City Project No.: 23-040

Addendum No.: 3

PROJECT TITLE: Water Line Replacement for 2024 Roads Program Construction

CITY OF TURLOCK
WATER LINE REPLACEMENT PLANS
S LAUREL STREET PLAN AND PROFILE

DWG NO. 23052DSGN.dwg LAYOUT: 17-PP SHEET: 17 OF 21

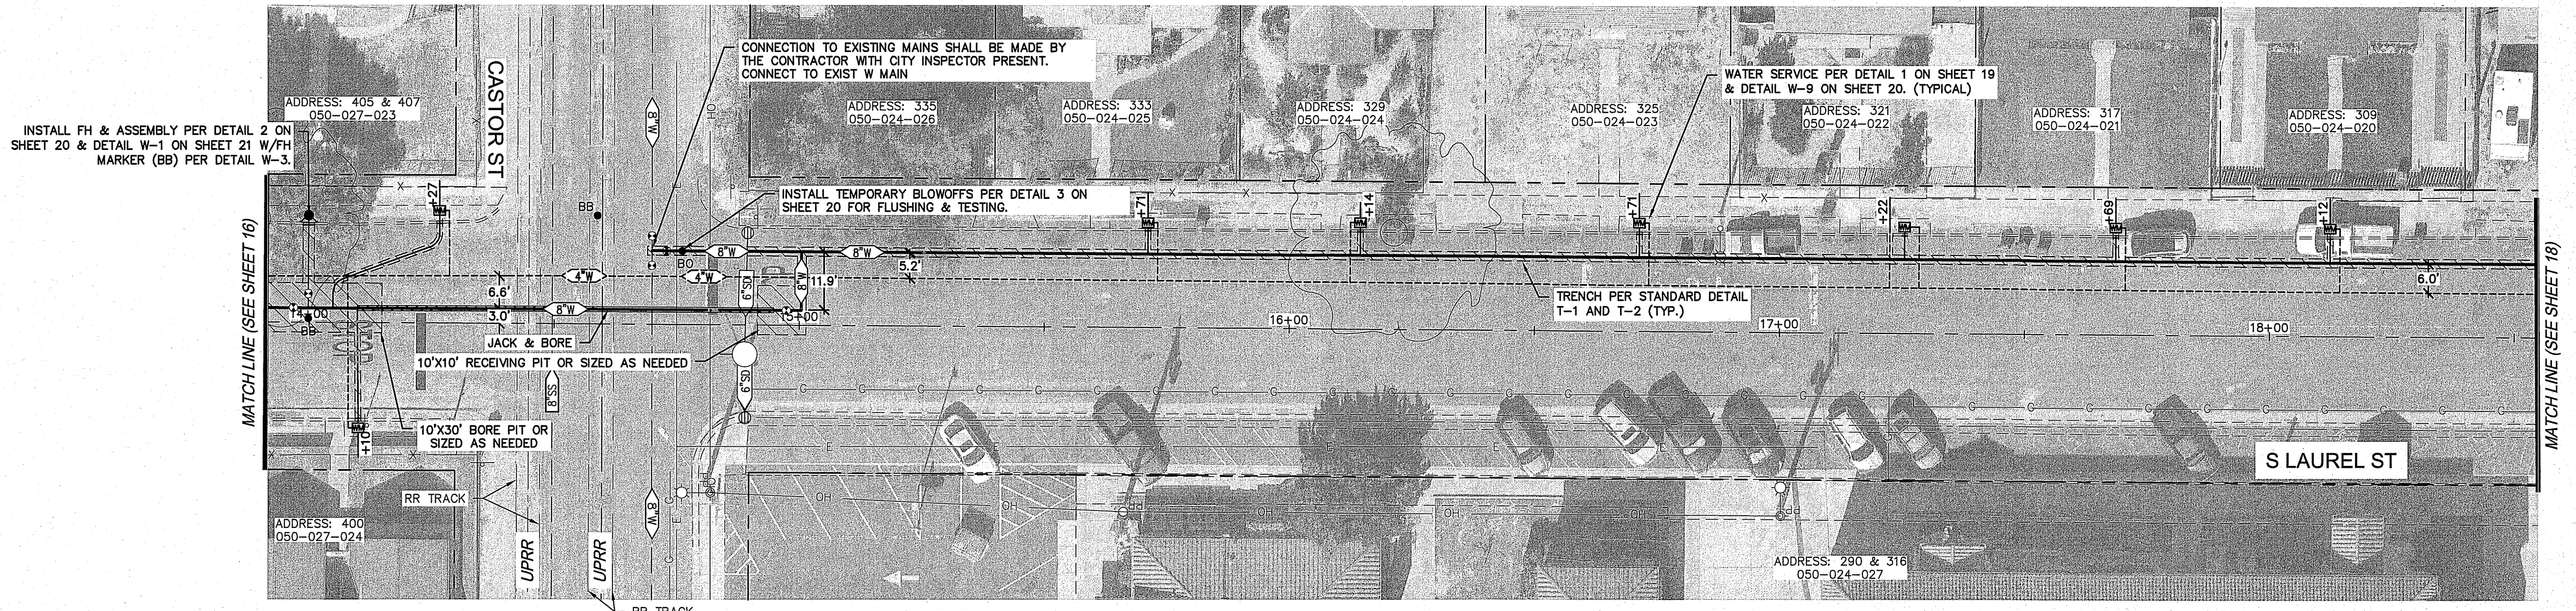
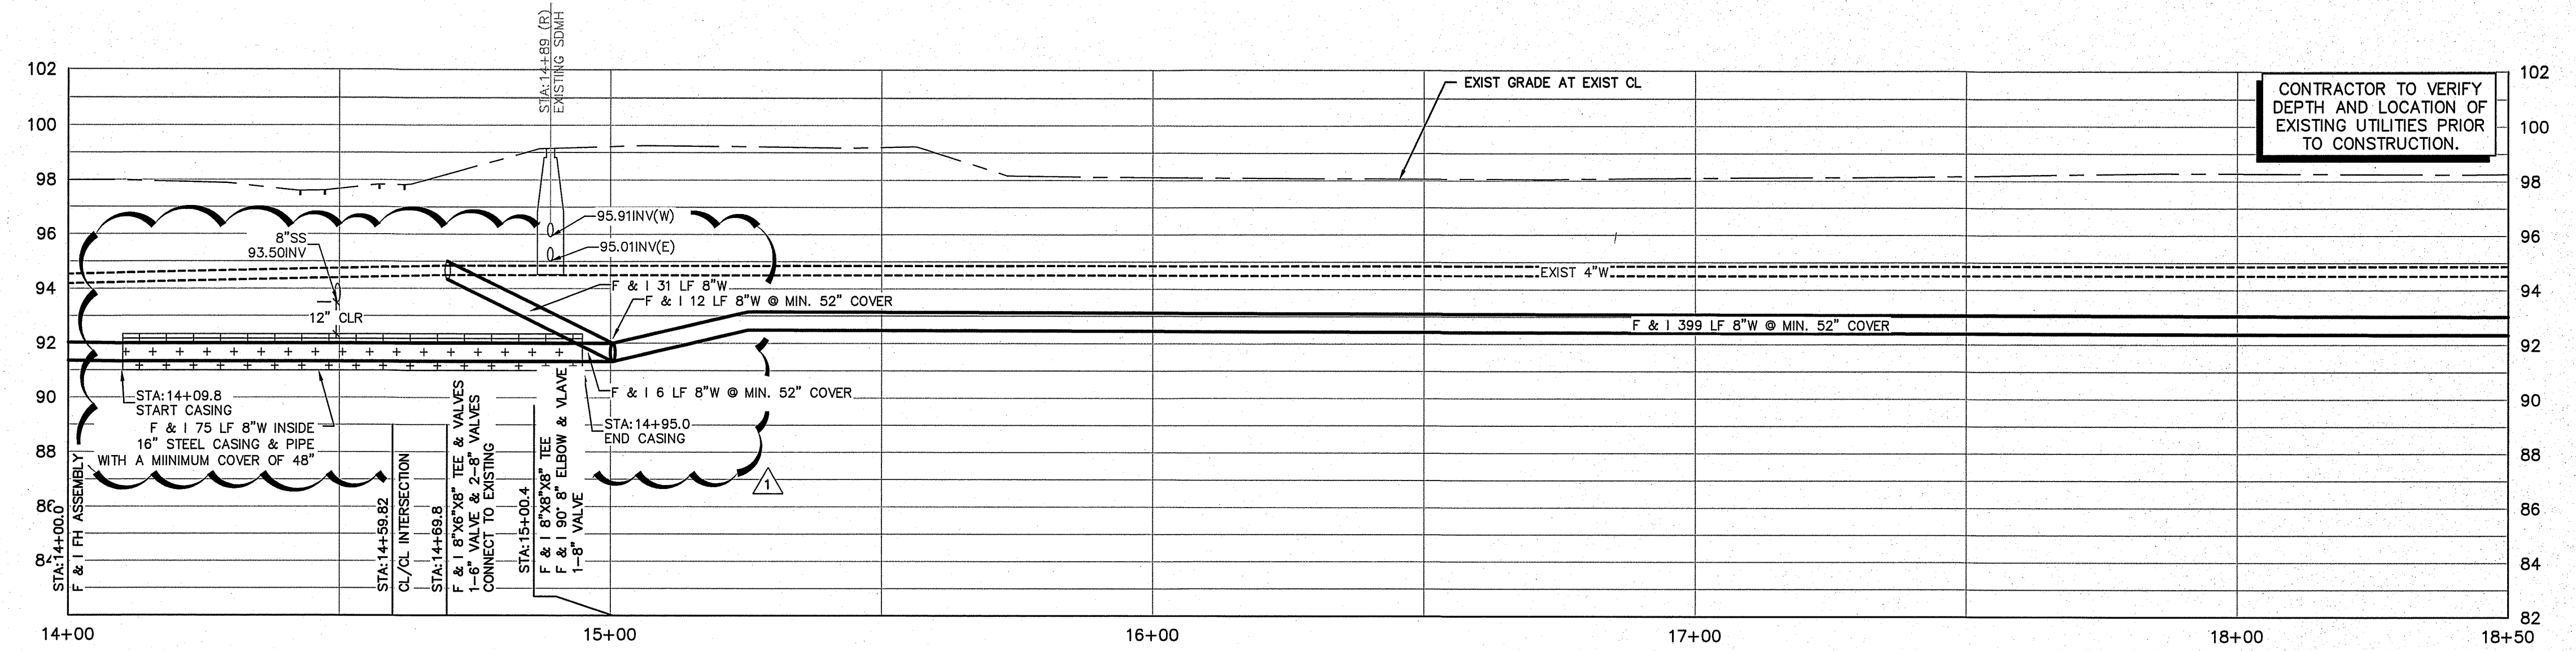
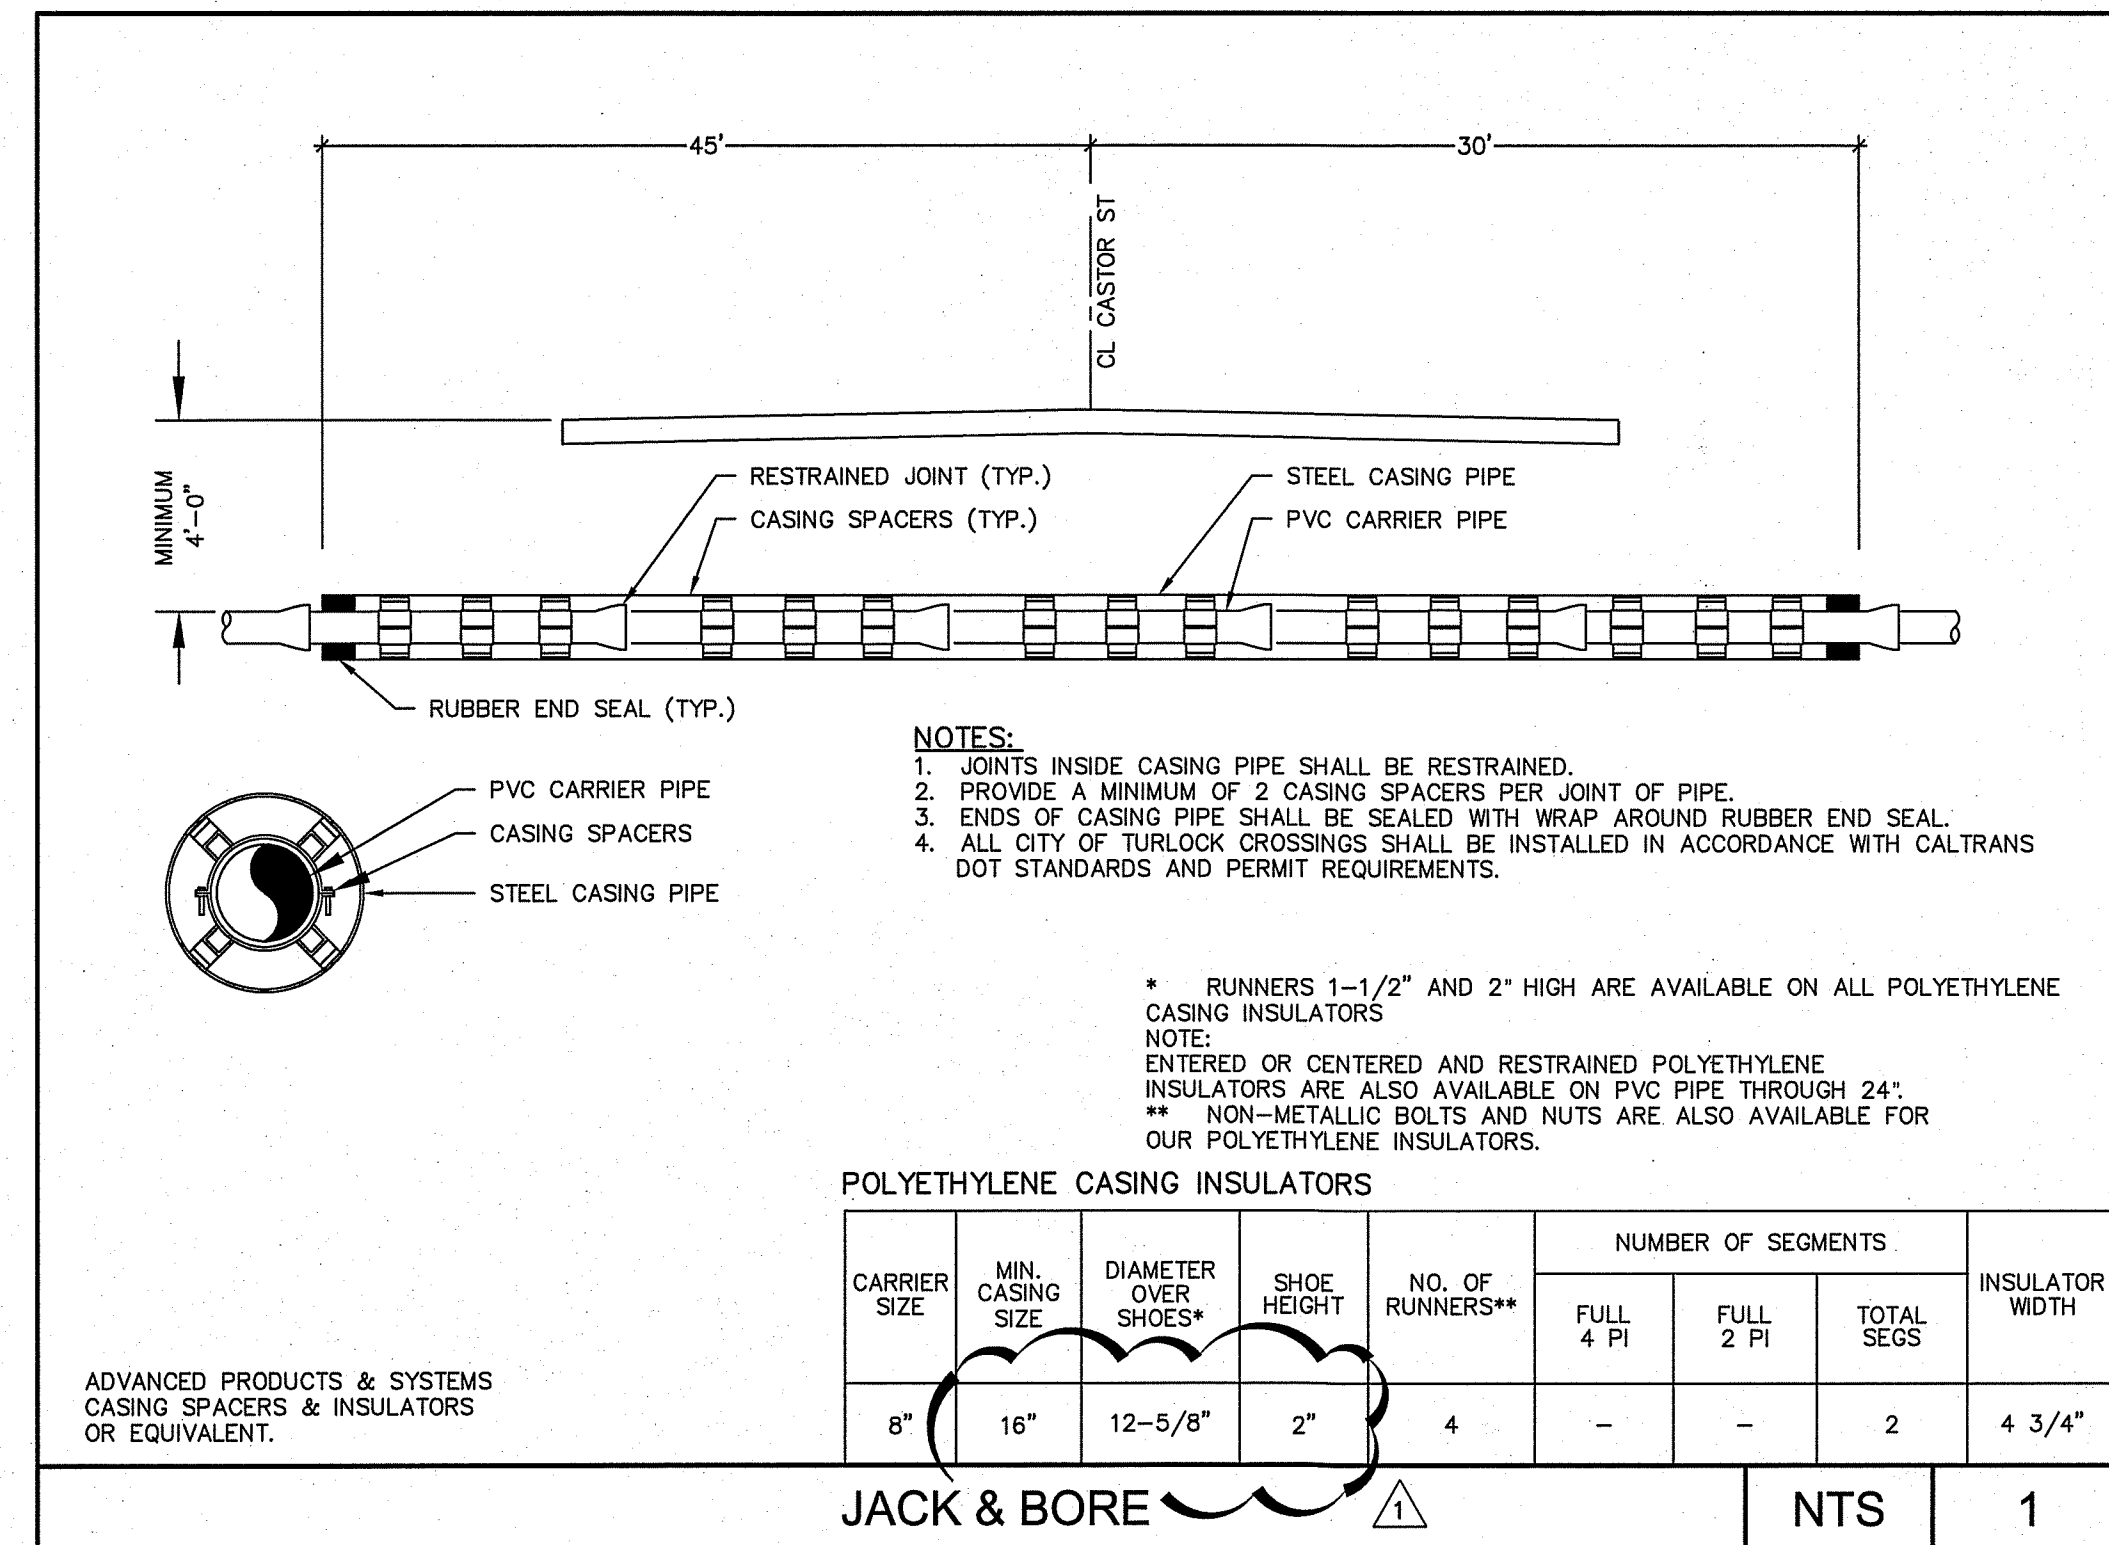
2. **Question:** Sheet 17 06 21 On the bore detail shows the PVC joints need to be restrained. A restrained 8” PVC Pipe using a standard ford pipe restraint will not fit in a 12” casing, it requires a minimum of 16” casing. Please advise.

REVISION	DESCRIPTION	DATE	BY
1	REVISED STEEL CASING SIZE FOR JACK & BORE	4/15/24	JA

Answer: Casing pipe size shall be 16 in. minimum. Refer to the revision issued in this Addendum No. 3 to Sheet 17 of the Project Plans.
